UNITED STATES PATENT AND TRADEMARK OFFICE

10/587,886

Office Action Summary	Application No. 10/587,886	Applicant(s) STEVENS, DONALD A.	
	Examiner Andrew J. Triggs	Art Unit 3635

DETAILED ACTION

FIG. 3

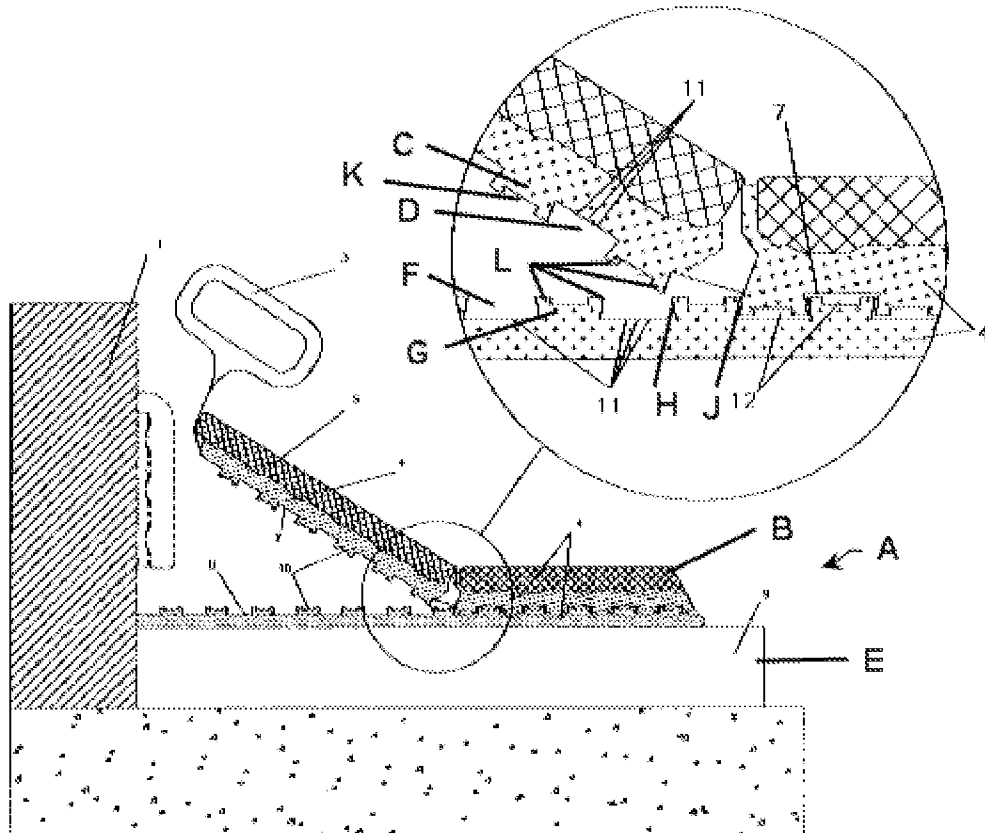
Regarding claim 1, Raineri teaches, in Figure 3 [annotated below], a framing system (A) that has a plank member (B) that has a front, generally flat, surface and an opposing back surface with at least one rib (C) protruding therefrom or at least one receptor pocket (D) extending therein. Raineri also teaches a frame member (E) of an underlying structure having at least one receptor pocket (F) extending therein or at least one rib (G) protruding therefrom, wherein the frame member (E) rib (G) or pocket (F) is matable with the plank member (B) pocket (D) or rib (C). Raineri also teaches the at least one rib (C and G) has a profile with a first side (H) and a second side (J) which diverge from one another as they extend away from the member (B and E) to which they are attached and then converge (Column 2, Lines 13-22). Finally, Rainer teaches the maximum height of a rib (C and G) occurs at the place of maximum divergence and the receptor pocket (D and F) has a minimum width less than that of the maximum height of the rib (C

Regarding claim 2, Raineri teaches, plank member (B) and the frame member (E) are secured to one another through the engagement of the at least one rib (C and G) with the at least one receptor (D and F) pocket.

Regarding claim 3, Raineri teaches in Figure 3, that one element (B) is inserted into the other (E) from above. The ribs (C and G) have a profile with sides that diverge (H and J). If the sides (H and J) of the ribs (C and G) were not resilient, the ribs (C

Regarding claim 4, Raineri teaches, in Figure 3, that the at least one rib (C) has a hollow interior (K) and the rib (C) bends for resiliency [as noted in claim 3].

Regarding claims 8 and 9, Raineri teaches in Figure 3, that one element (B) is inserted into the other (E) from above. The ribs (C and G) have a profile with sides that diverge (H and J). If the sides (H and J) of the ribs (C and G) and receptors (D and F) were not resilient, the ribs (C and G) could not be inserted into the receptors (D and F) since the tips of the edges would interfere. Thus the at least one receptor pocket (D and F) has walls which are resilient and the walls of the at least one receptor pocket (D and F) must be pushed apart to accommodate the rib (C and G).

Regarding claim 10, Raineri teaches, in Figure 3, that at least one rib (C and G) has barbs (L) on it.

Regarding claim 12, Raineri teaches, in Figure 3, that the at least one receptor pocket (F) is within the frame member (E) and wherein the at least one rib (C) is within the plank member (B).

Regarding claim 13, Raineri teaches, in Figure 3, that the at least one rib (C) is a separate piece (7) secured to the back surface of the plank member (B).

Regarding claim 14, Raineri teaches, in Figure 3, that the at least one receptor pocket (D) is in the plank member (B) and the at least one rib (G) is in the frame member (E).

Regarding claims 15 and 16, Raineri teaches, in Figure 3, that each plank member (B) interlocks with an adjacent plank member (B) and the plank members (B) are overlapping with adjacent plank members (B).

Regarding claim 17, Raineri teaches, in Figure 3 [annotated above], a plank member (B) comprising: a front, generally flat, surface and an opposing back surface with the at least one rib protruding therefrom (C); wherein the at least one rib (C) has a profile similar to another rib with a first side (H) and a second side (J) which diverge from one another as they extend away from the member (E) to which they are attached and then converge; wherein the maximum height of a rib (C) occurs at the place of maximum divergence such that the rib (C) is adapted to be received within a receptor pocket (F) having a minimum width less than that of the maximum height of the rib (C).

Regarding claim 19, Raineri teaches, in Figure 3 [annotated above], a frame member (E) of an underlying structure, wherein the frame member (E) comprises: at least one receptor pocket (F) extending therein, wherein the pocket (F) is adapted to receive a rib (C); wherein the receptor pocket (F) has a minimum width less than that of the maximum height of the rib (C) such that the rib (C) may be captured within the receptor pocket (F).

Regarding claim 20, as per claim 19, Raineri teaches a frame member of an underlying substructure. Raineri does not teach the frame member is a C-shaped structural member. However, Raineri does teach that the portion (7) containing the ribs (G) and pockets (F) is separate and attached via adhesive (4). The portion (7) would have been capable of being attached to a C-shaped structural member, thus allowing planks (B) to be attached to the structural member. Therefore, the
